Staff Report
City of Richmond, Virginia

Commission of Architectural Review

1. COA-104543-2022	Final Review	Meeting Date: 1/25/2022
Applicant/Petitioner	Linnea Gerwig	
Project Description	Demolish a non-original addition and construct a new rear, two-story addition and shed.	
Project Location		
Address: 612 N. 27 th St.		
Historic District: Church Hill North		
High-Level Details: <ul style="list-style-type: none"> The applicant proposes to alter the rear of an 1820s Federal Style, three-bay frame house. The applicant proposes to demolish a non-original rear addition and construct a new two-story addition with a larger footprint in its place. No changes to the front façade are proposed. The applicant also proposes to construct a new storage building to the rear of the existing dwelling along the alley. Minor, in-kind repairs to the front façade are also proposed. 		
Staff Contact	Alex Dandridge, alex.dandridge@RVA.gov , 804-646-6569	
Previous Reviews	The application was reviewed conceptually at the December 2021 meeting and the Commission had no major comments.

Figure 4. Footprint of original dwelling depicted on F.W. Beers Atlas (c. 1877)

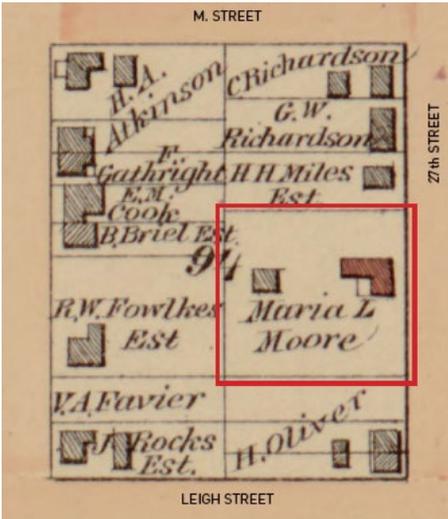
<p>Residential Outbuildings, pg. 51 #1-3</p>	<ol style="list-style-type: none"> 1. <i>Outbuildings, including garages, sheds, gazebos and other auxiliary structures, should be compatible with the design of the primary building on the site, including roof slope and materials selection.</i> 2. <i>Newly constructed outbuildings such as detached garages or tool sheds should respect the siting, massing, roof profiles, materials and colors of existing outbuildings in the neighborhood.</i> 3. <i>New outbuildings should be smaller than the main residence and be located to the rear and/or side of the property to emphasize that they are secondary structures.</i> 	<p>The proposed accessory structure is comparable in massing and form to other outbuildings in the area and is subordinate in size to the principal dwelling. The proposed design uses materials that will match the proposed rear façade addition. <u>If the Commission determines that a contemporary design is appropriate for the proposed attached addition, staff recommends approval of the accessory structure, as proposed.</u></p> <p>Additionally, staff notes that historic maps indicate that accessory structures have been present on the property at various times (see Figures 4-6).</p>
